Levy Nuclear Plant, Units 1 & 2

COL Application

Technical Specifications

Section A. PSTS and Bases Differences from the DCD GTS and Bases (LNP COL 16.1-1)

FIGURE 4.1-1 Site and Exclusion Boundaries

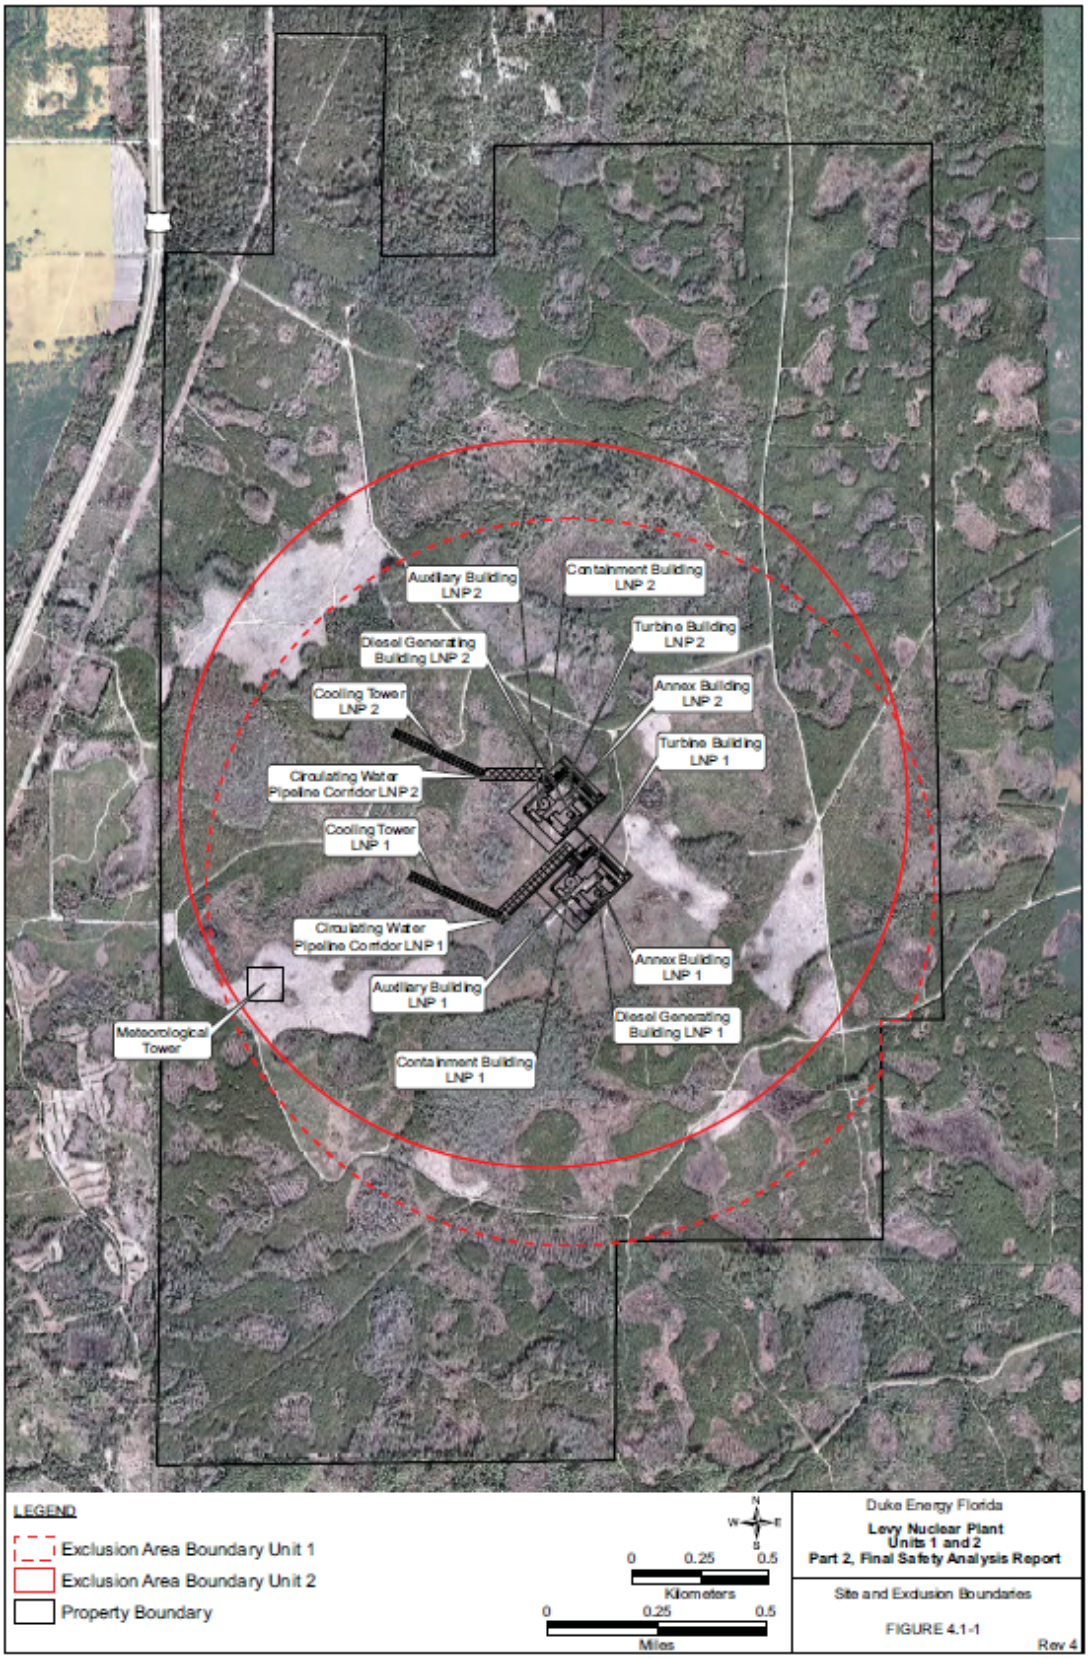
GTS 4.1.1 The bracketed information in the GTS reads:
[This information will be provided by the combined license applicant.]

Replace the bracketed information in the GTS with the following:

The Site and Exclusion Area Boundaries are shown in Figure 4.1-1.

Justification:
Bracketed information is replaced to establish Site Boundary and Exclusion Area Boundary for LNP consistent with the descriptions identified in FSAR Sections 2.1.1.2 and 2.1.1.3.

FIGURE 4.1-2 Low Population Zone (LPZ)

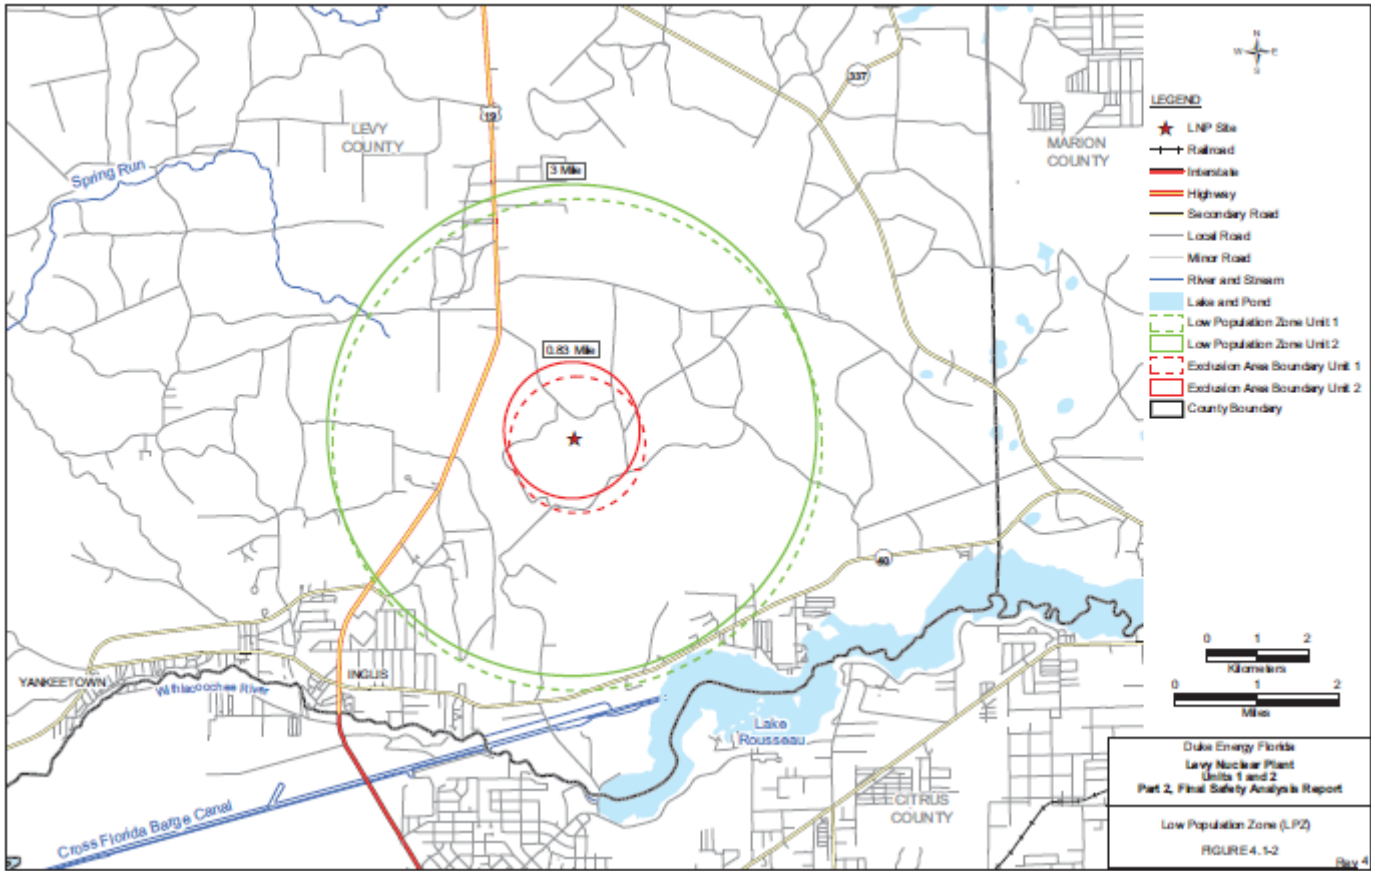
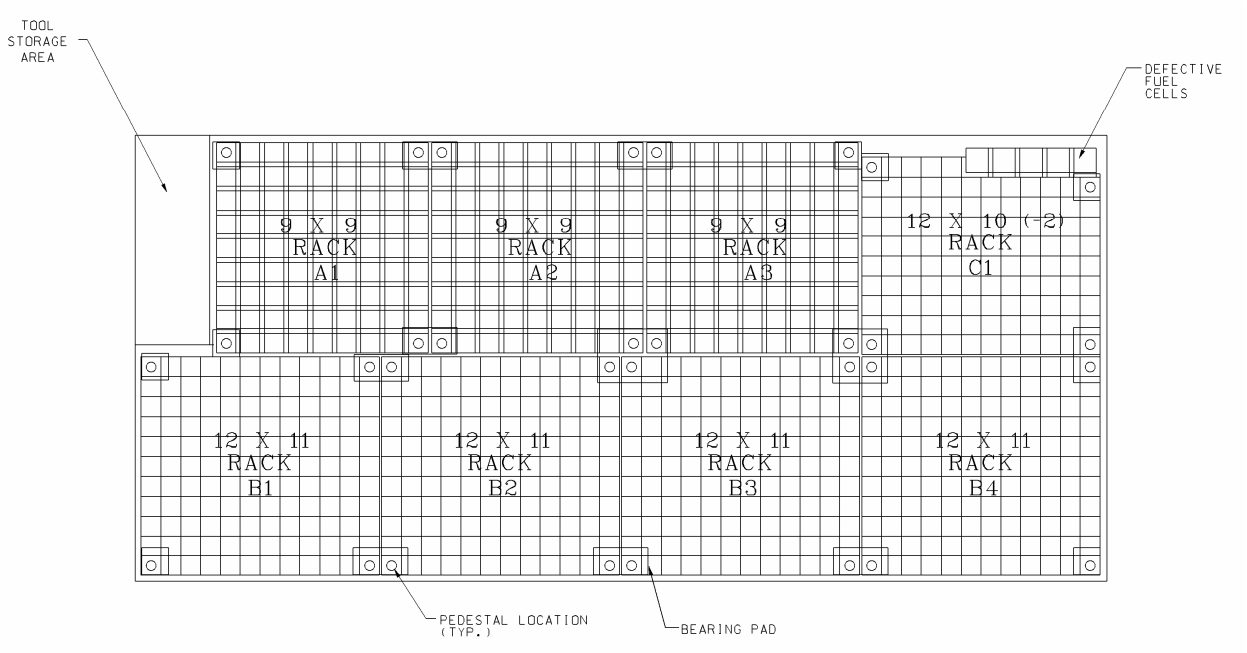
GTS 4.1.2 The bracketed information in the GTS reads:
[This information will be provided by the combined license applicant.]

Replace the bracketed information in the GTS with the following:
The LPZ is defined by the 3 mile radius from the site center point as shown in Figure 4.1-2.

Bracketed information is replaced to establish the LPZ for LNP consistent with the descriptions identified in FSAR Section 2.1.3.4.

Figure B 3.6.8-1 (page 1 of 1)
Time Prior to Coolant Inventory Boiling

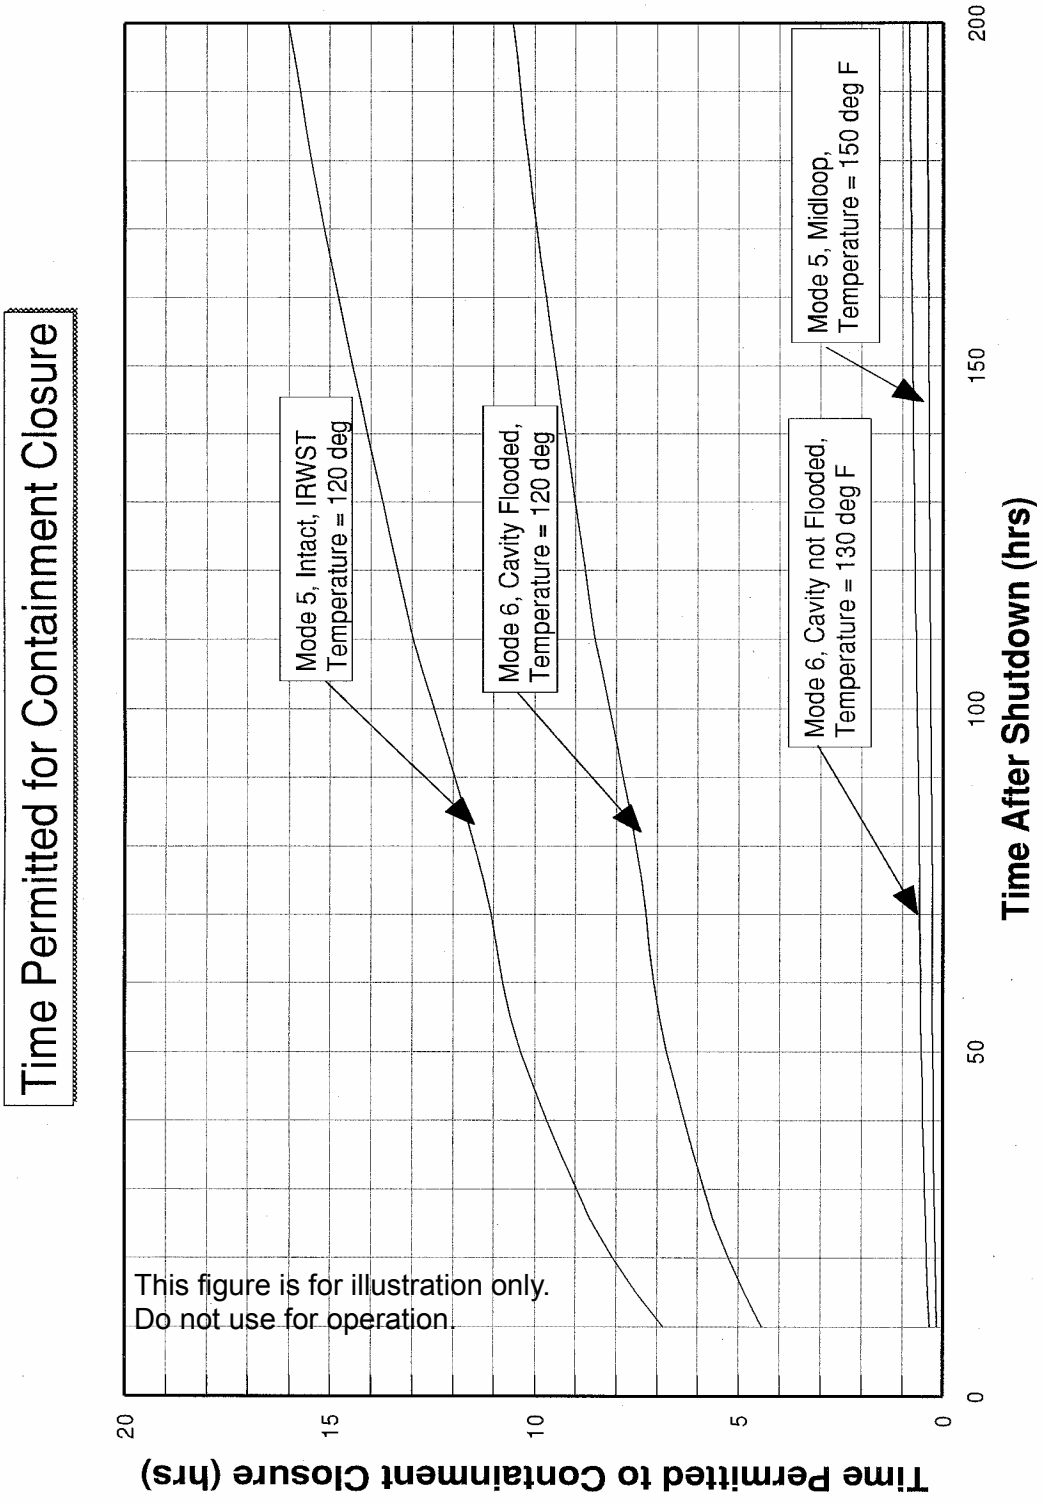
GTS B3.6.8 The Bases for Specification 3.6.8 contain a bracketed figure which addresses the anticipated time prior to coolant inventory boiling under various conditions.

Remove the reviewer note in the PSTS. There is no replacement language.
